North Anna Power Station Audit Report Corrective Actions for Generic Letter 2004-02: Chemical Effects

1.0 INTRODUCTION

Figure 2: Prepared Fibrous Debris Slurry for a Multi-Loop Rig Test

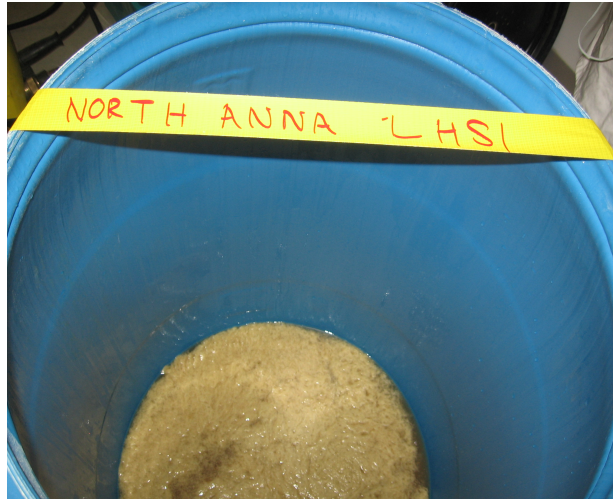
- First, the transport of part of the fibrous debris to the floor of the strainer box resulted in a splitting of each fibrous debris batch into two sub-batches, with the first sub-batch likely having an increased fraction of the finest debris fragments.

- Second, the intermediate step of settling part of the fibrous debris onto the strainer box floor prior to its arrival on the strainer could have provided an opportunity for fine debris to agglomerate into debris pieces of increased size. However, the NRC staff did not directly observe agglomeration of this debris, and it can be seen above in Figure 6 that the small clumps of fibrous debris that settled on the tank floor apparently remained relatively loose and fluffy.

Figure 6: Fibrous Debris Settled in a Strainer Box

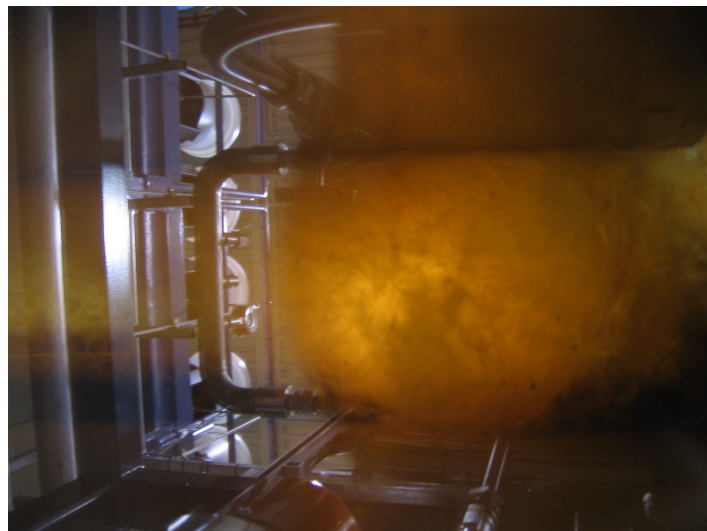
- Following the addition of a batch of fibrous debris, the floors of the strainer boxes were typically brushed to re-suspend settled debris. The NRC staff observed that, in some cases, the head loss increase following the brushing of the tank was comparable to or greater than the increase associated with the fibrous debris addition itself. This observation indicated that a significant amount of the debris entering the strainer box likely first settled onto the strainer box floor and then was subsequently brushed back into suspension and drawn onto the strainer by the flow through the loop. The NRC staff noted three possible effects of this transport sequence:

- Third, the NRC staff also observed that a small quantity of the particulate debris remained on the strainer box floor after the addition of several batches of fiber had clarified the test fluid. The cyclical re-suspension of this settled particulate when the strainer box floor was brushed following the addition of batches of fibrous debris appeared to be equivalent to an addition sequence wherein a portion of the particulate loading was added to the debris bed in a staggered pattern with batches of fiber.
